TOLLING AGREEMENT

15495 Los Gatos Boulevard, Los Gatos

**STAFF TECHNICAL REVIEW
PLANNING DIVISION
December 23, 2024**

PROJECT PLANNER: Sean Mullin
LAST REVIEWED BY STAFF: Second Review

c) ~~The required setbacks shown on the site plan are not correct. Show the correct required setbacks and label them.~~

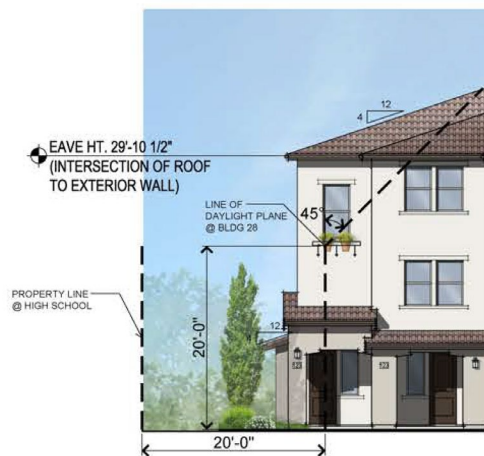
The following minimum yard requirements apply along those property lines of a lot in the CH zone which abut or are across the street from a lot in a residential zone:

Front25 feet

Side15 feet

Rear20 feet

11/26/24 Response: *All the required and proposed setbacks were indicated on the site plan and clouded on sheet A-1.00. Also added to the project information on sheet A-0.01.*

Staff Response: Additional sections or elevations needed showing the required setback as it increases with building height. Example provided below.

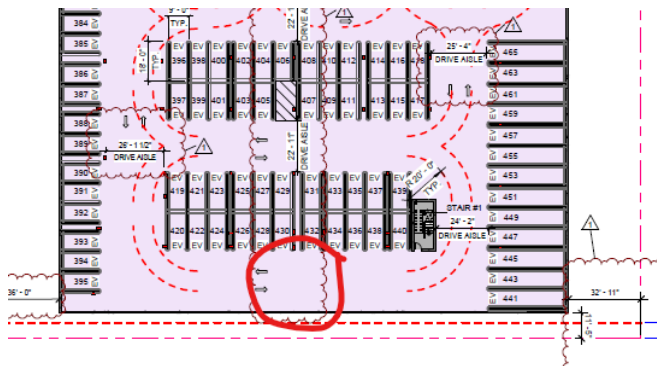
- a) Aisle widths shall be a minimum of 22 feet for two-way aisles. Several two-way aisles do not meet the 22-foot width requirement. [29.10.155 (d)(2)]

Staff Response: Add dimension to the circled aisle on Sheet A-2.00 shown below.

11/26/24 Response: All the drive aisles were revised to meet the min 22' width and clouded on basement and 1st floor plans, sheets A-2.00 and A-2.01.
